RE: **Comments of the Minnesota Department of Commerce, Division of Energy Resources**
Docket No. E017/M-19-260

Otter Tail Power Company's Annual Safety, Reliability and Service Quality Report and Proposed SAIFI, SAIDI and CAIDI Reliability Standards for 2019.

Comments of the Minnesota Department of Commerce Division of Energy Resources

Docket No. E017/M-19-260

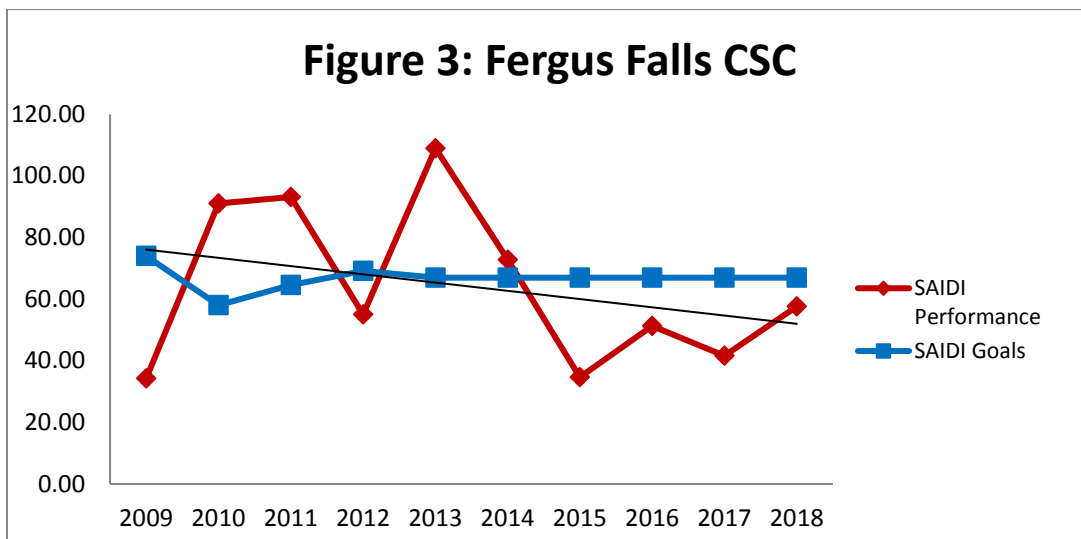
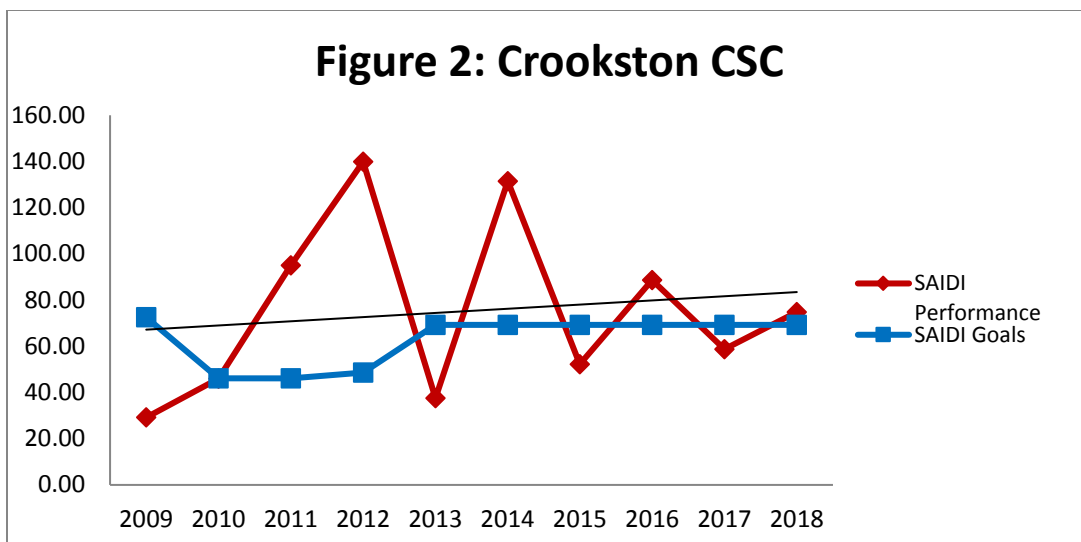
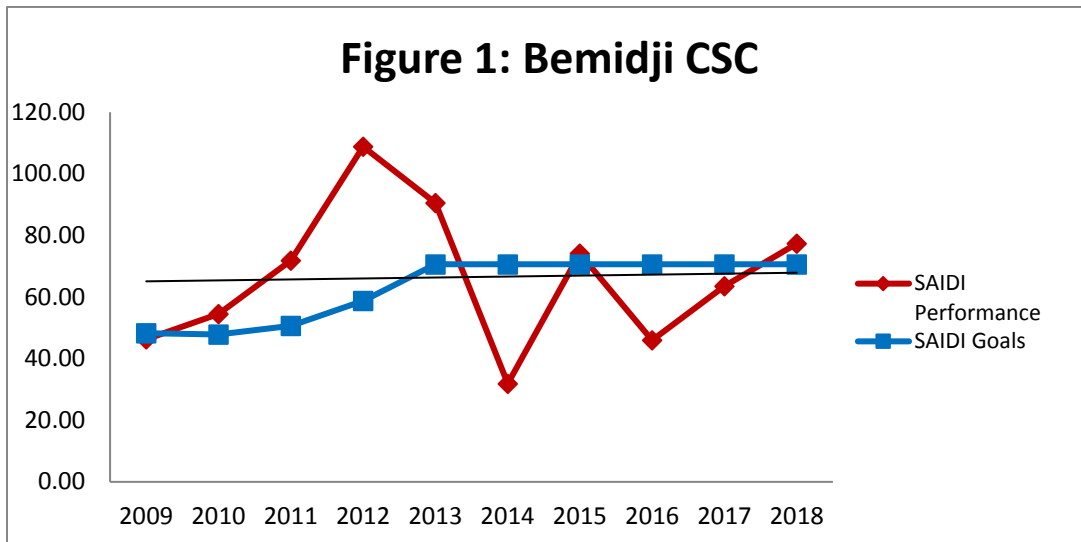
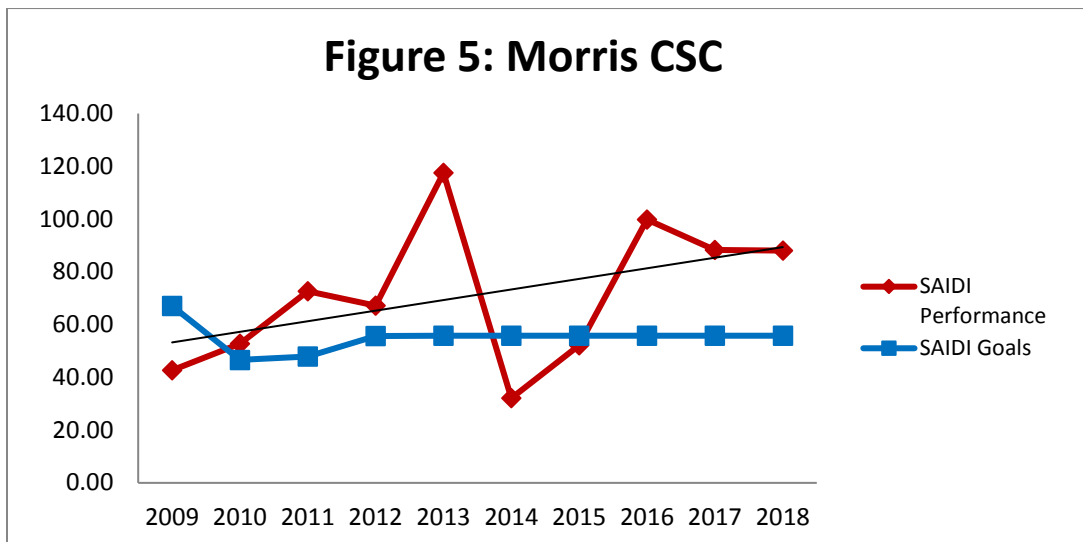
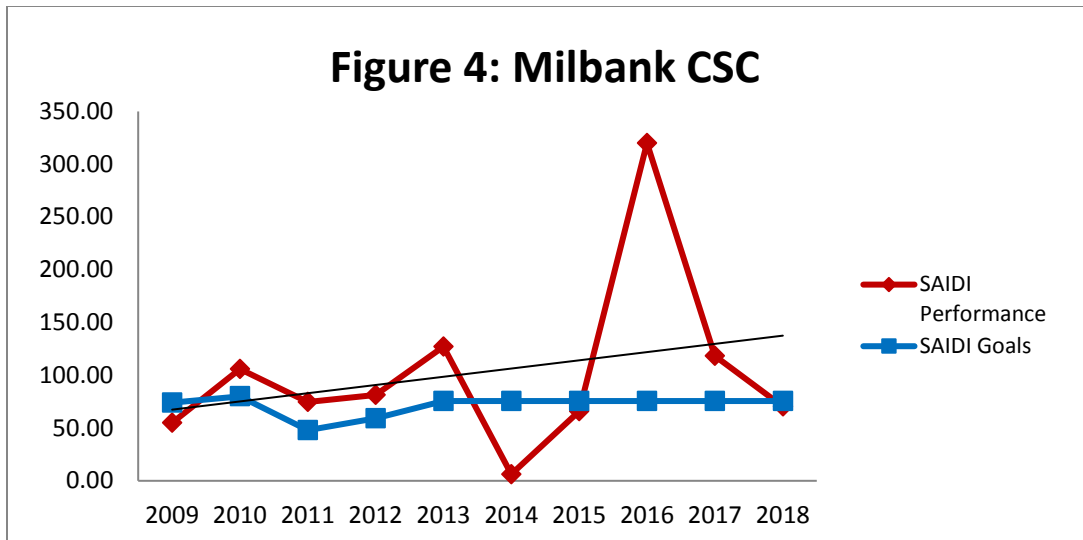
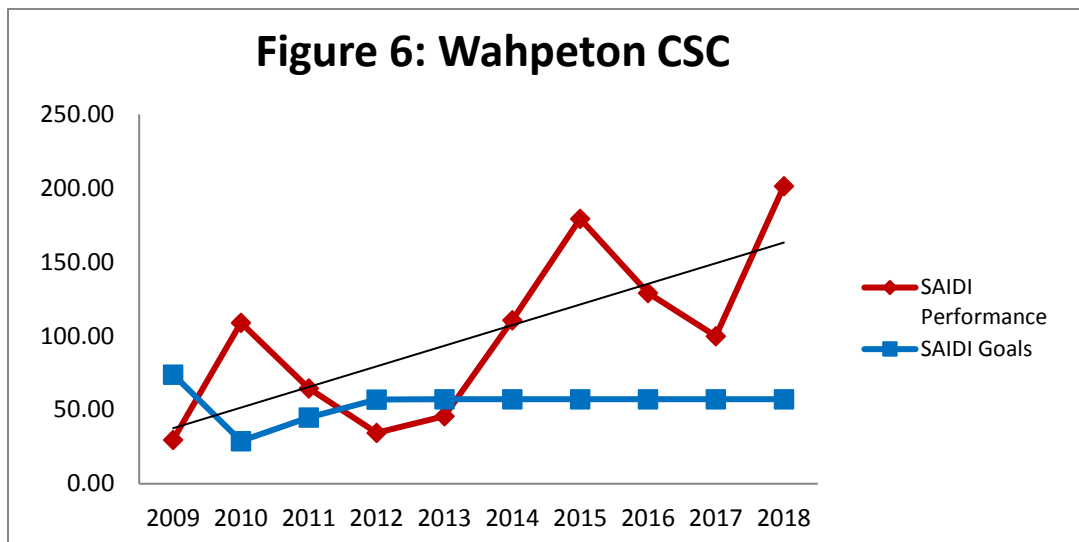
The following figures highlight OTP's SAIDI performance trends for the six CSCs from 2009-2018, including a black trend line to indicate performance patterns overtime. It should be noted that all CSCs other than Bemidji and Fergus Falls show trends of worsening performance.

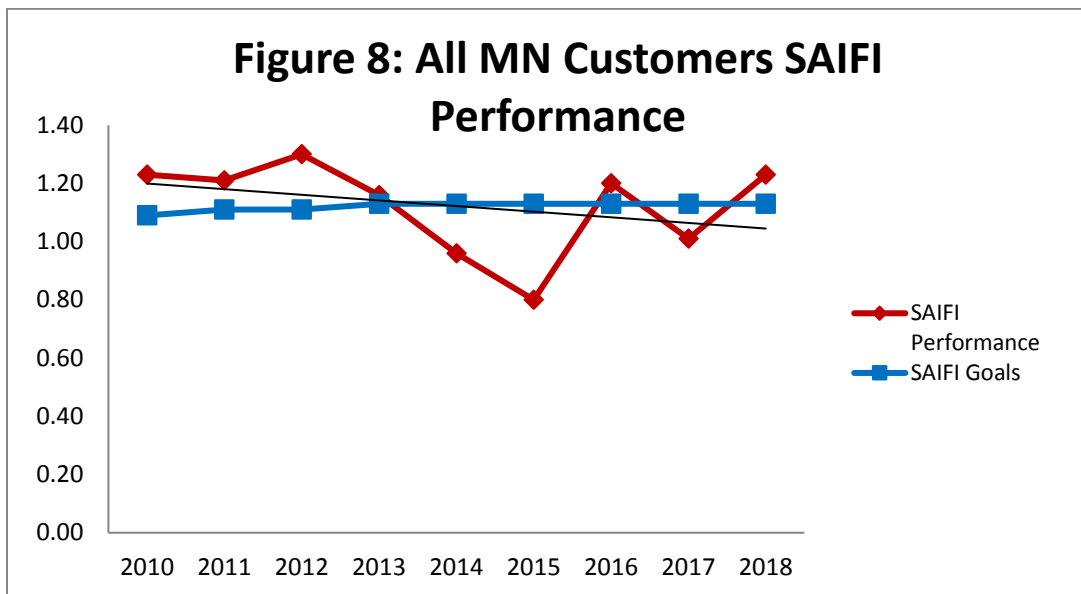
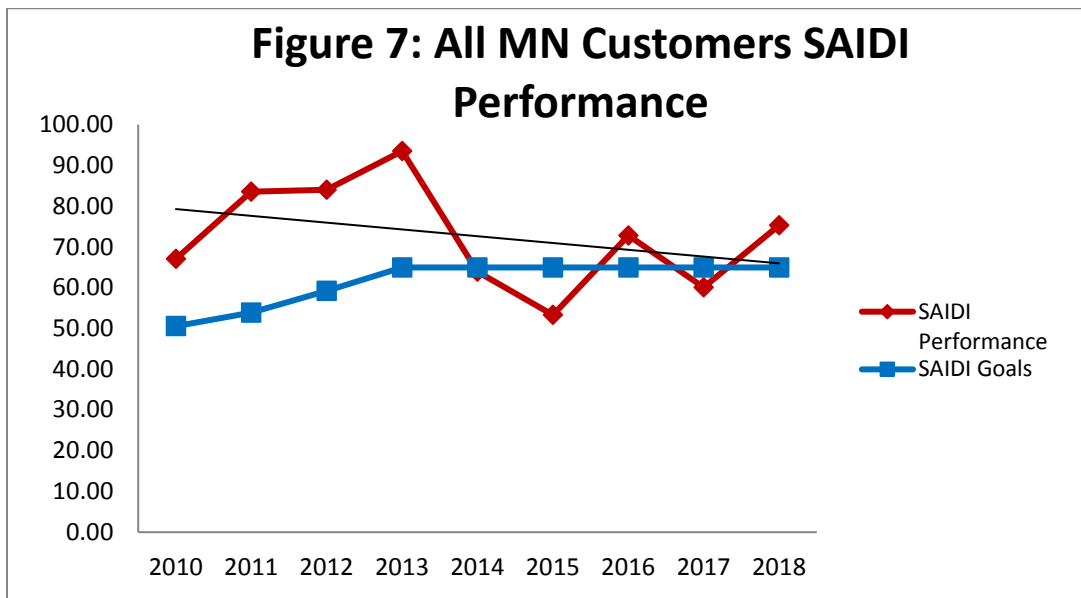
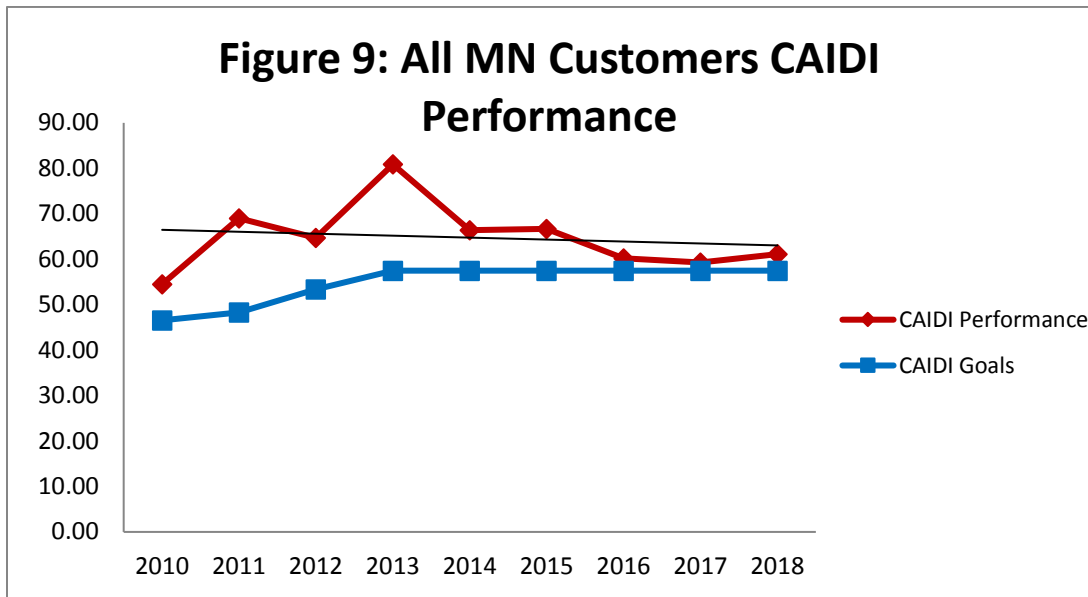
While the Company had seen a retrogression in its SAIDI and SAIFI performance in 2016 and 2018, the overall trend of the past nine years has been in an improving direction, as shown in Figures 7 and 8 below. The Company's CAIDI performance has remained relatively flat over that time, but has missed its goal in each of the nine years.

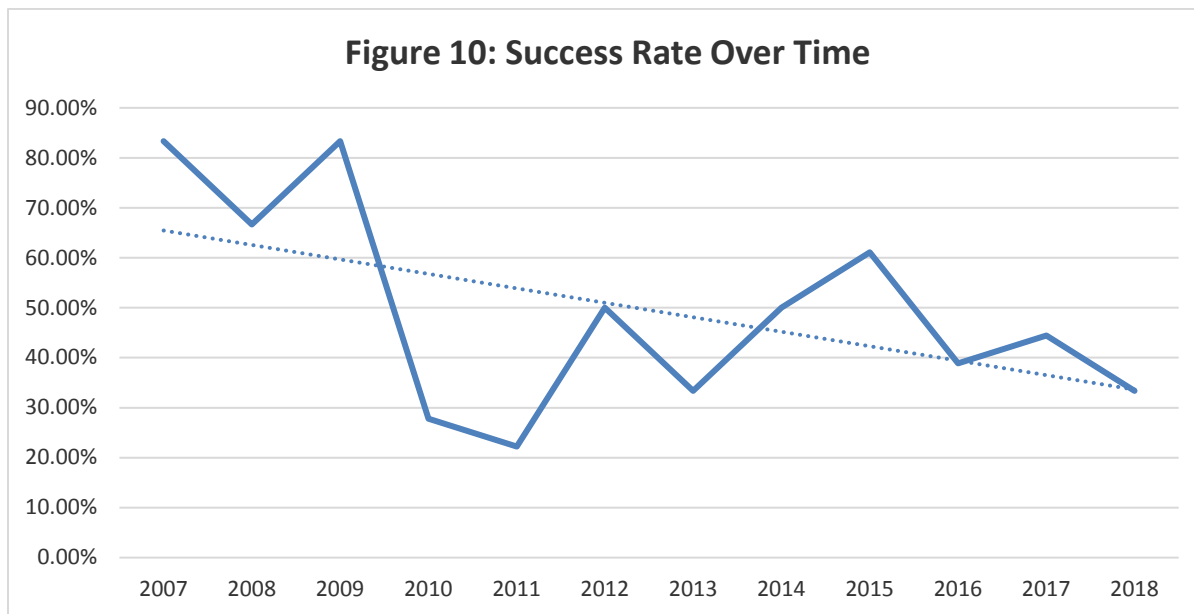
As can be seen from Figure 10 above, OTP has trended downward over time regarding its ability to meet its goals. On average, since 2007, OTP has achieved approximately 50 percent of its goals, with 2018 coming in lower than that at approximately 33 percent. The Department recommends that the Company’s goals remain frozen at 2013 levels until performance improves. The Department notes that data from OTP’s new IMS may support revisions to the Company’s reliability goals, once sufficient data are available indicating improved reliability.
